Access Compliance Report Public Rights-of-Way (Curb Ramps)

Main Street: MCCORMACK_LN Cross Street: SHADBURN_AVE Location: NE

ADA ID: RPRK210917161354 Ramp Type: Type 1 - Perpendicular Diagonal Initial Pass/Fail: Pass Overall Compliance: No Severity Score: 6

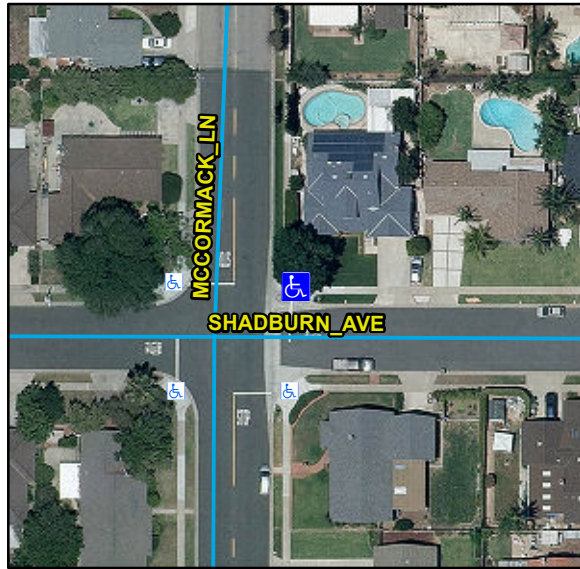
Compliance	Description	Data	Compliance	Description	Data
N/A	Ramp Length (in)	101	N/A	Flare Type LT	
Yes	Ramp Width (in)	48			Sloped
Yes	Ramp Run Slope (%)	3.3	N/A	Flare Slope LT (%)	7.9
Yes	Ramp Cross Slope (%)	0.6	N/A	Flare Traversable LT	No
N/A	Landing Present	Yes	N/A	Flare Type RT	
N/A	Landing Length (in)	35			Sloped
Yes	Landing Width (in)	48	N/A	Flare Slope RT (%)	7
Yes	Landing Run Slope (%)	2	N/A	Flare Traversable RT	No
Yes	Landing Cross Slope (%)	0.9	Yes	DWS Provided	Yes
N/A	Landing Movement Obstructed?	Yes	Yes	DWS Contrast	Yes
	Landing Movement Type	Curb	Yes	DWS Length (in)	36
N/A	Landing Shared	No	Yes	DWS Full Width	Yes
N/A	Clear Space	Yes	Yes	DWS Offset Left (in)	0
N/A	Clear Space To Crosswalk (in)	48	Yes	DWS Offset Right (in)	N/A
N/A	Marked Crosswalk 1	No	N/A	Marked Crosswalk 2	No
	Crossing 1 Direction	W		Crossing 2 Direction	S
	Marked Crosswalk 1 Width (in)	N/A		Marked Crosswalk 2 Width (in)	N/A

Remove & Replace Landing.
